GAINES PLACE SUBDIVISION

<u>Engineering Comments:</u> FINAL PLAT COMMENTS (should be addressed prior to submitting the FINAL PLAT for acceptance and signature by the City Engineer):

The plat illustrates the proposed 1-lot, $0.14\pm$ acre subdivision which is located on the North side of Dauphin Street, 165' East of North Broad Street, within Council District 2. The applicant states that the subdivision is served by city water and sanitary sewer systems. The purpose of this application is to create one (1) legal lot of record from a single metes-and-bounds parcel.

DETAIL SITE PLAN

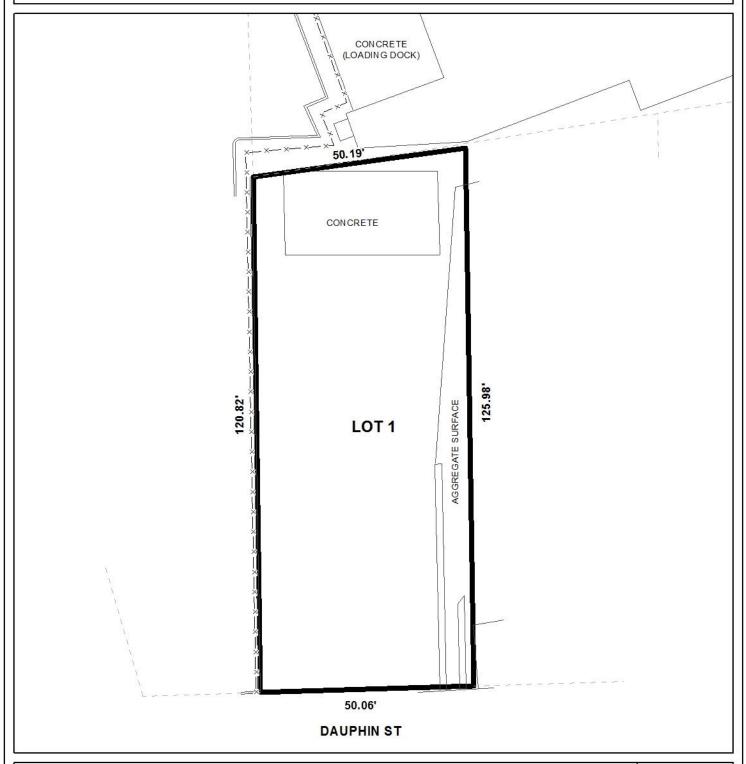
- B. Add a vicinity map.
- C. Correct the drawing or the scale. They did not match on the drawing that was reviewed.
- D. Show and label all flood zones.

- E. Show and label the MFFE (Minimum Finished Floor Elevation) on each lot that contains an AE, V, or X (shaded) flood zone designation.
- F. Add a signature block for the Owner, Notary Public, Planning Commission, Traffic Engineer, and City Engineer.

Per Section 64-4.I.8.(d), the DDD allows from 0' minimum to 12' maximum setback along all street frontages. The preliminary plat shows no setback requirements. If approved, the Final Plat should be amended to depict a 12' maximum building setback line along all frontages along with a note stating a 0' minimum is allowed.

The lot size labels in both square feet and acres should be retained on the Final Plat or a table should be furnished on the Final Plat providing the same information. As a means of access management, a note containing the Traffic Engineering comments should be placed on the Final Plat.

- 1) retention of the lot size labels in both square feet and acres on the Final Plat or the furnishing of a table on the Final Plat providing the same information;

- 2) revision of the Final Plat to depict a 12' maximum building setback line along all frontages along with a note stating a 0' minimum is allowed;
- 3) compliance with the Engineering comments: FINAL PLAT COMMENTS (should be addressed prior to submitting the FINAL PLAT for acceptance and signature by the City Engineer): A. Provide all of the required information on the SUBDIVISION PLAT (i.e. signature blocks, signatures, certification statements, written legal description, required notes, legend, scale, bearings and distances) that is required by the current Alabama State Board of Licensure for Professional Engineers and Land Surveyors. B. Add a vicinity map. C. Correct the drawing or the scale. They did not match on the drawing
